Access Compliance Report

Public Rights-of-Way

(Pedestrian Signals)

Intersection ID: N/A	Main Street:	Cross Street: N/A	Location: N/A
ADA ID: EA5E3C50B64B	Signal Type: One Push Button-APS	Overall Compliance: No	Severity Score: BTN 1: N/A BTN 2: N/A No BTN: N/A
Codes/Mitigation Info/Possible Solution		Field Measurements/Component Compliance

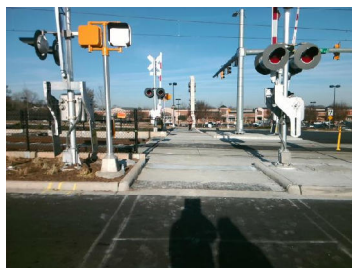
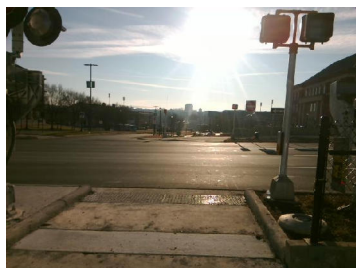
N/A	B 1 FWD Approach Width (in)	N/A	N/A	B 2 FWD Approach Width (in)	N/A
N/A	B 1 FWD Approach Obstruction?	Yes	N/A	B 2 FWD Approach Obstruction?	N/A
N/A	B 1 FWD Approach Obstruction Dist (in)	4.0	N/A	B 2 FWD Approach ObstructionDist (in)	N/A
N/A	B 1 PARA Approach?	Yes	N/A	B 2 PARA Approach?	N/A
N/A	B 1 PARA Approach Constrained?	Yes	N/A	B 2 PARA Approach Constrained?	N/A
No	B 1 PARA Approach Reach (in)	17.0	N/A	B 2 PARA Approach Reach (in)	N/A
No	B 1 PARA Approach Width (in)	48.0	N/A	B 2 PARA Approach Width (in)	N/A
N/A	B 1 PARA Approach Obstruction?	Yes	N/A	B 2 PARA Approach Obstruction?	N/A
N/A	B 1 PARA Approach Obstruction Dist (in)	5.0	N/A	B 2 PARA Approach ObstructionDist (in)	N/A
No	B 1 Clear Floor Space Slope (%)	N/A	N/A	B 2 Clear Floor Space Slope (%)	N/A
No	B 1 Clear Floor Space XSlope (%)	N/A	N/A	B 2 Clear Floor Space XSlope (%)	N/A
N/A	B 1 PAR Slope (%)	N/A	N/A	B 2 PAR Slope (%)	N/A
Yes	B 1 Height (in)	37.0	N/A	B 2 Height (in)	N/A

N/A	B 1 Clear Xing Direction?	Yes	N/A	B 2 Clear Xing Direction?	N/A
	B 1 Crossing Direction	To SE		B 2 Crossing Direction	N/A
Yes	B 1 DistanceTo XWalk (in)	17.0	N/A	B 2 DistanceTo XWalk (in)	N/A
No	B 1 DistanceTo Curb (in)	16.0	N/A	B 2 DistanceTo Curb (in)	N/A
Yes	B 1 Diameter (in)	2.0	N/A	B 2 Diameter (in)	N/A

Possible Solutions: Replace Signal Push Button With APS Button on New Post. Remove & Relocate Sign.

PROW/ADA: TMUTCD 4e.08, R404.2, R404.3, R404.7.3, R404.7.2
